FAIRFIELD TOWNSHIP BOARD OF ZONING APPEALS
STAFF REPORT

CASE: FTZA17-9CU

REQUEST: Conditional Use to build a 220 multi-family units
(retail uses are an allowed use in B-3)

DATE: October 22, 2017

PRELIMINARY SITE DRAWING

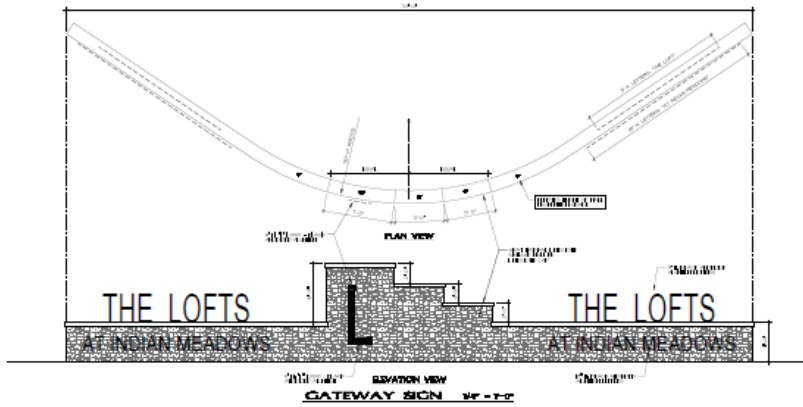
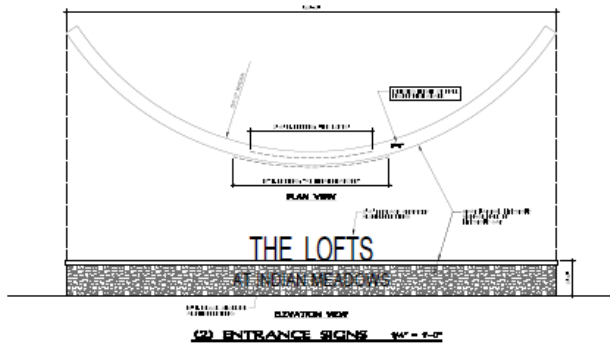
Density calculates to 17.5 units per acre *which exceeds zoning code 13R.4.1.5*. The code suggests a maximum density of 13 units per acre. The developer has been creative in keeping space within the development while increasing density to allow for viability by using a three-story building model.

Article 23.1.2.4 requires 2.0 off street parking spaces per unit for Multi-family residential use. Based on the current 220 unit request the development is required to provided 440 parking spaces. The current plan has 367 parking spaces, which is 1.7 parking spaces per unit. Three

options to be considered are as follows: 1) approve the 1.67 parking spaces per unit. 2) allow the adjustment from 20' x 9' spaces to 18' x 9' spaces (option 2 would gain 16 spaces, 383 total spaces or 1.74 spaces per unit) or 3) add an overflow parking area to retail Lot 1 to meet the required spaces.

4. That all apartment buildings provide a 50 foot buffer from existing adjacent single family residential lots. The buffer will also need to include vegetative screening that includes large evergreen trees to create a natural physical barrier to light, sound, to create privacy for all residents.

Based on the findings of fact, the Zoning Resolution, and the Fairfield Township Vision Plan staff makes the recommendation to deny the conditional request unless all of the following conditions are met:
